HUNTER
MARINE CORPORATION
AN EMPLOYEE OWNERSHIP COMPANY

SB# 01-D, I

Dear H45CC Owner (Hull Numbers covered by this Bulletin are HUN4C101F506 through HUN4C170C708).

DRAWING TITLE: **ENGINE PANEL WIRING**

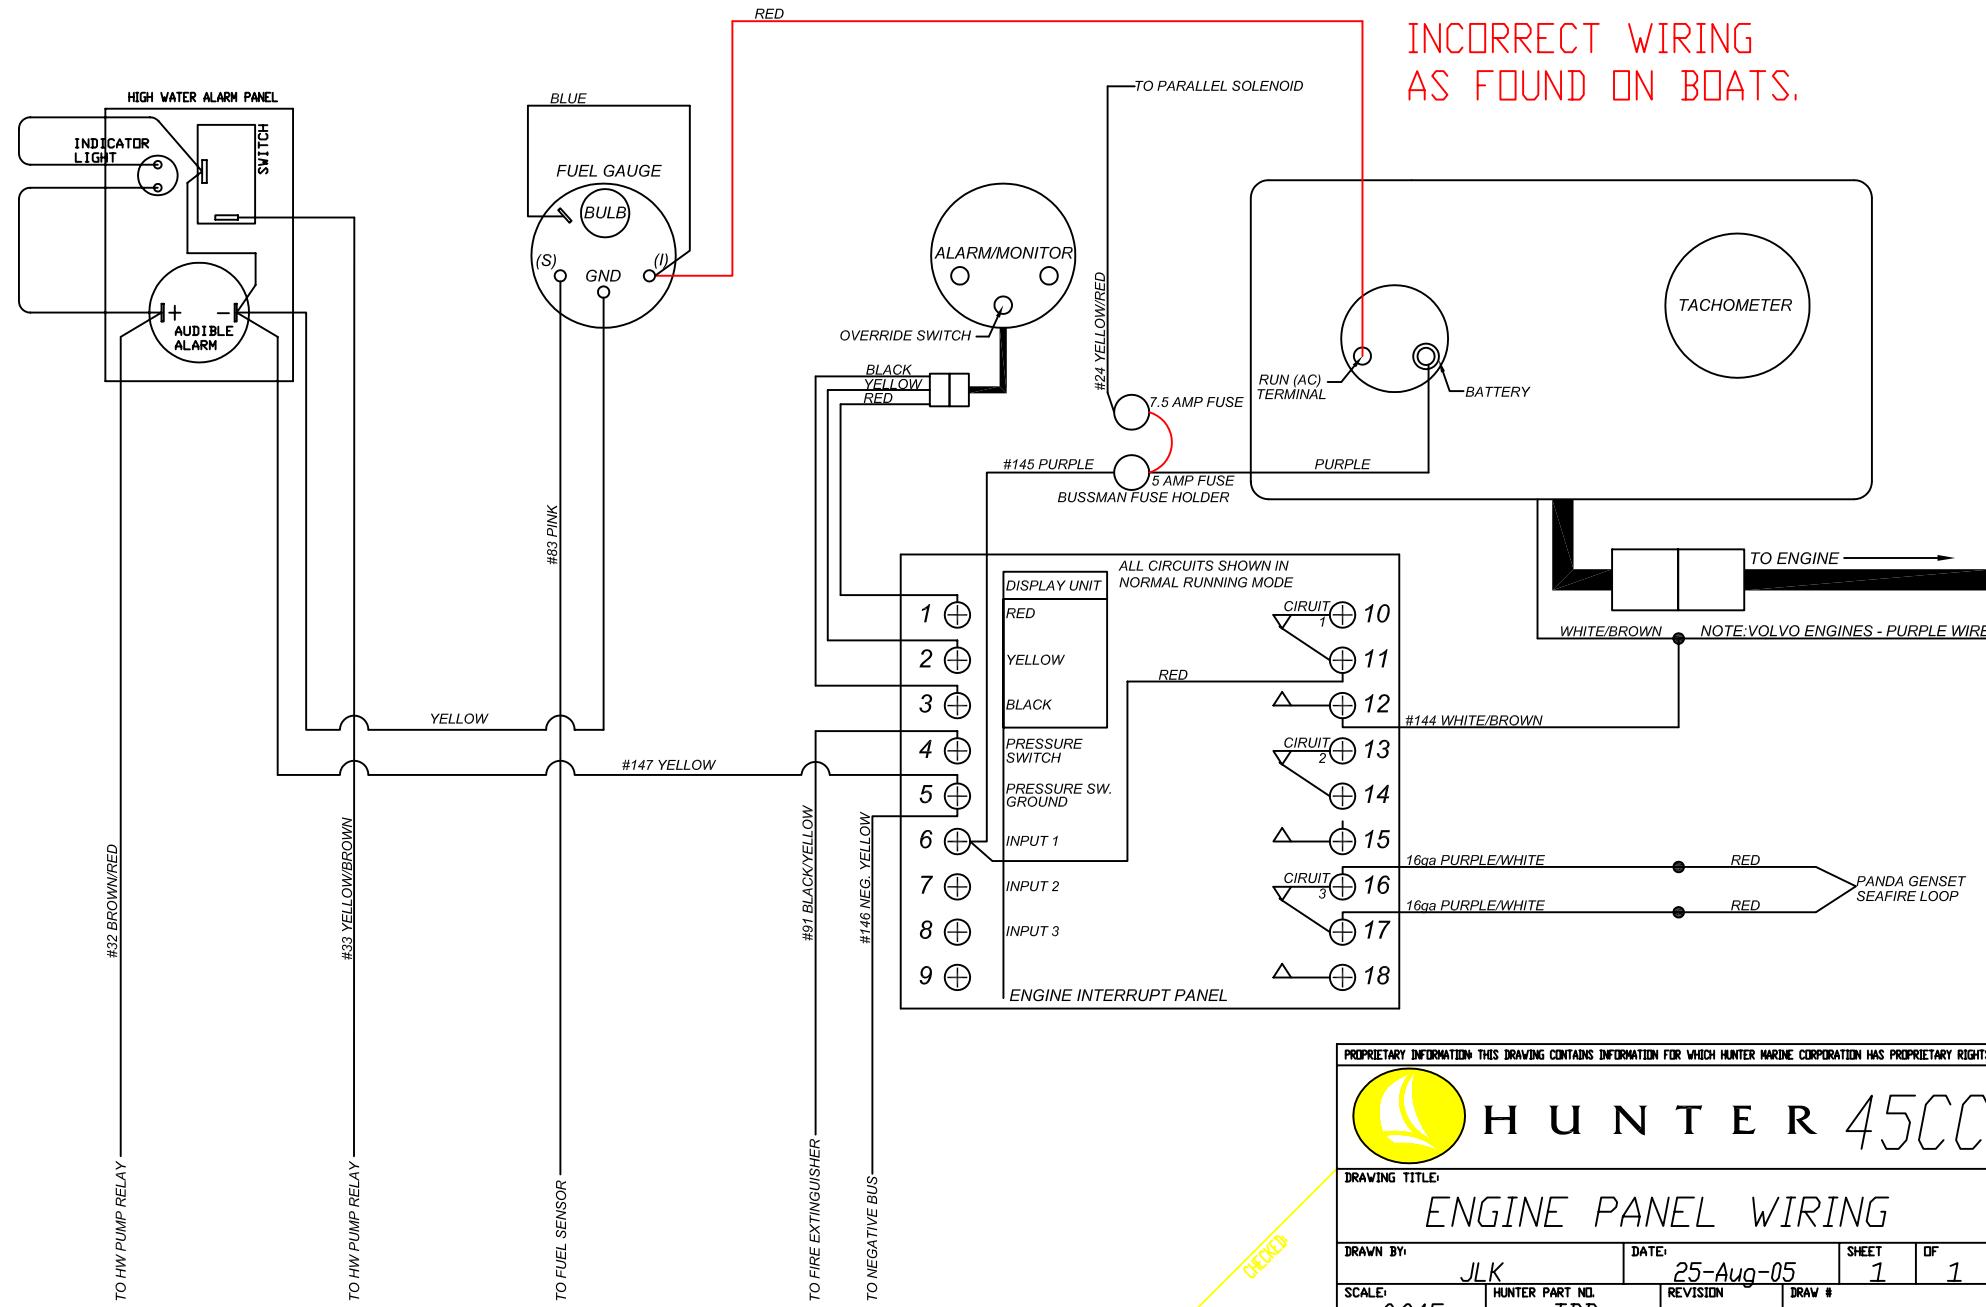
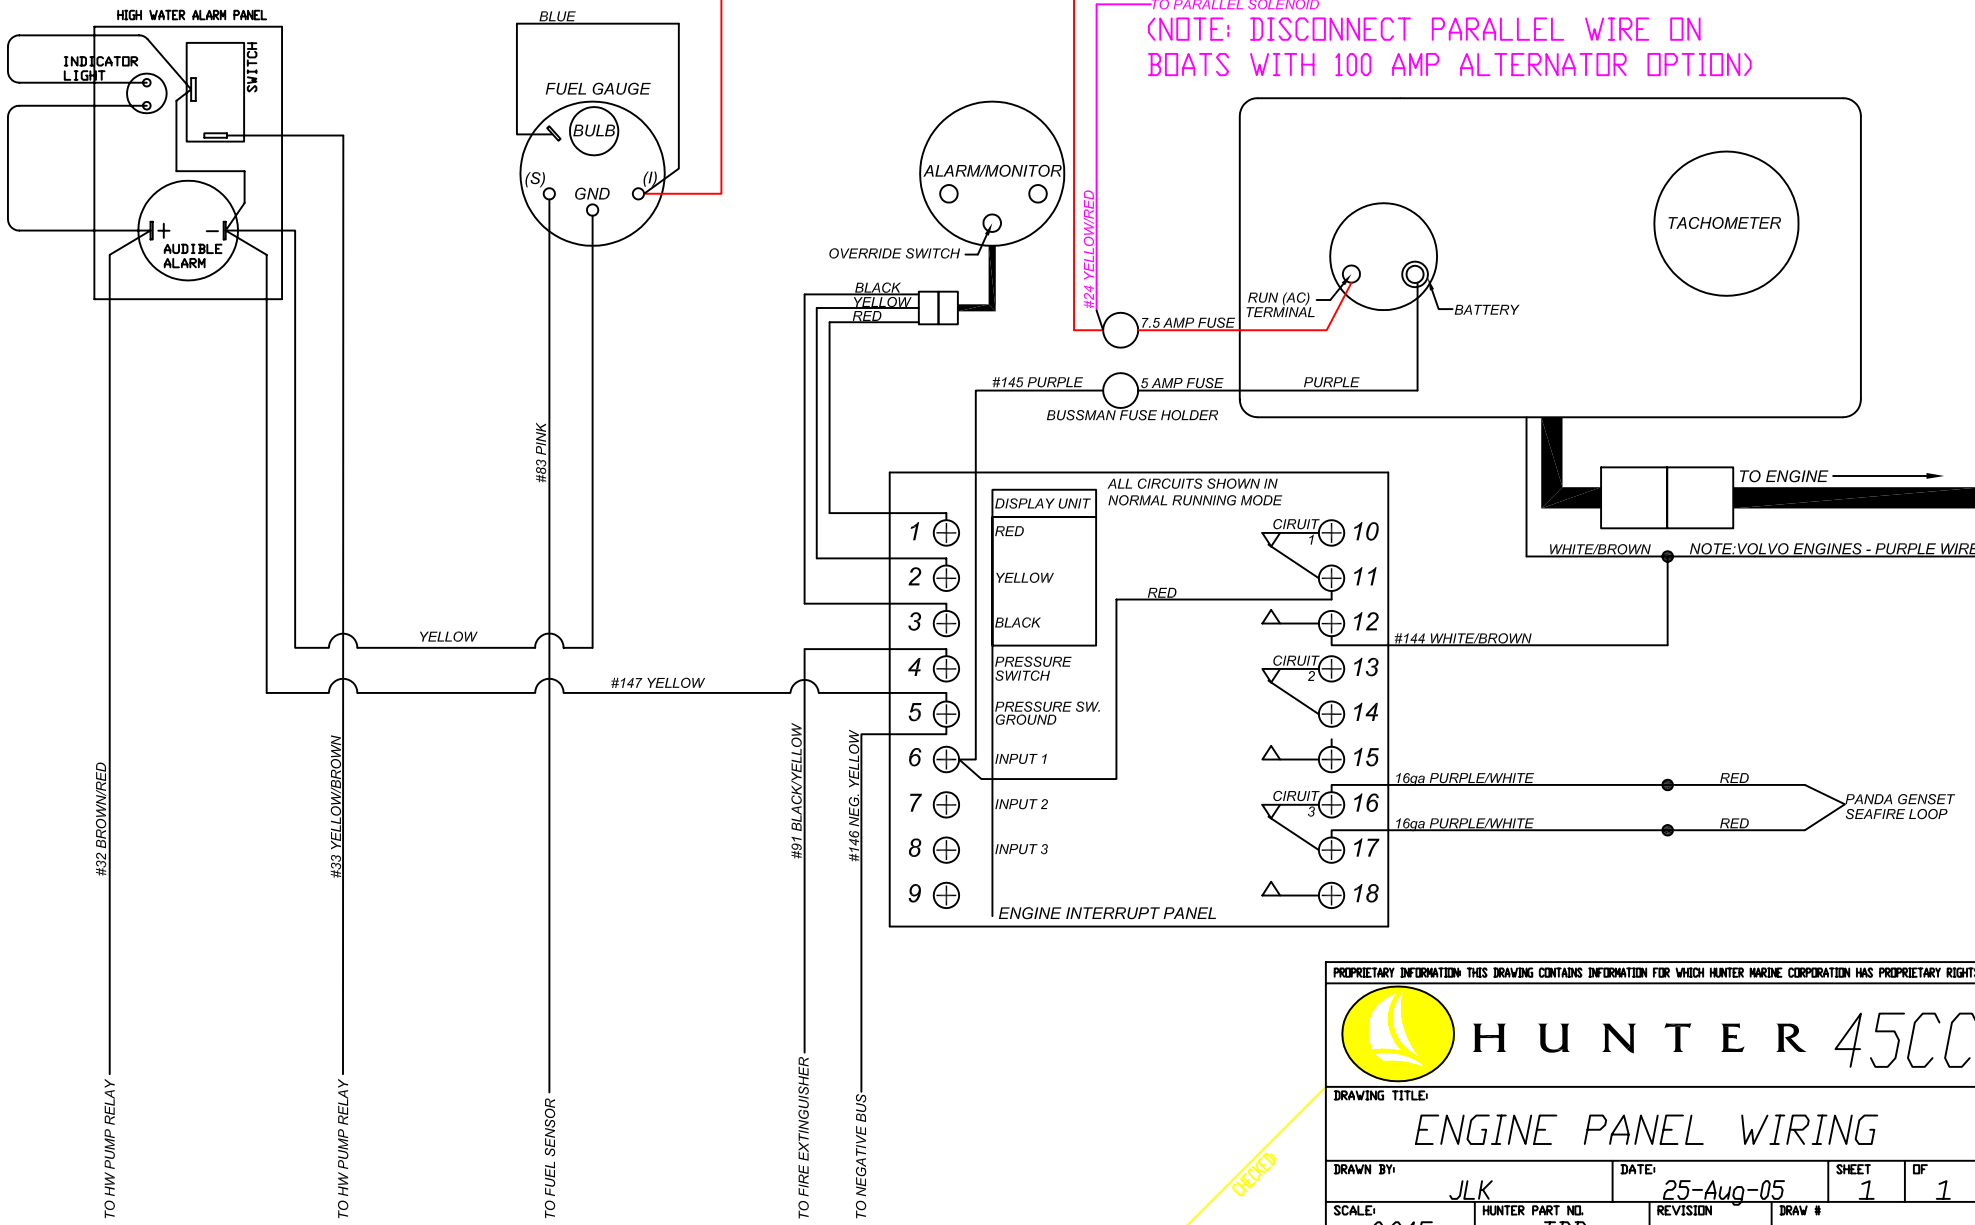
It has come to our attention at Hunter Marine that we committed an error in wiring the engine start panel installed on your boat. It is our opinion that this wiring error does not cause any safety concern, but will lead to a premature drainage of your boat's main batteries under certain conditions.

We are making arrangements through our dealer network for this wiring correction to be made at our expense. We were able to simulate this inspection and repair in less than 30 minutes at the Hunter Marine factory. We have attached two drawings, which show both the correct and incorrect wiring schematic of the engine start panel. If your engine start panel does not match the correct wiring then the correction needs to be completed before your boats next use. Without the correction, your boat's main batteries are subject to drainage, leaving them in a condition that will not allow for the starting of the main drive engine or optional generator. Failure to complete the corrections where it is required, will lead ultimately to the drainage of the batteries and perhaps even premature damage to the batteries themselves.

INCORRECT WIRING AS FOUND ON BOATS.

CORRECTED WIRING

TO PARALLEL SOLENOID
 (NOTE: DISCONNECT PARALLEL WIRE ON
 BOATS WITH 100 AMP ALTERNATOR OPTION)
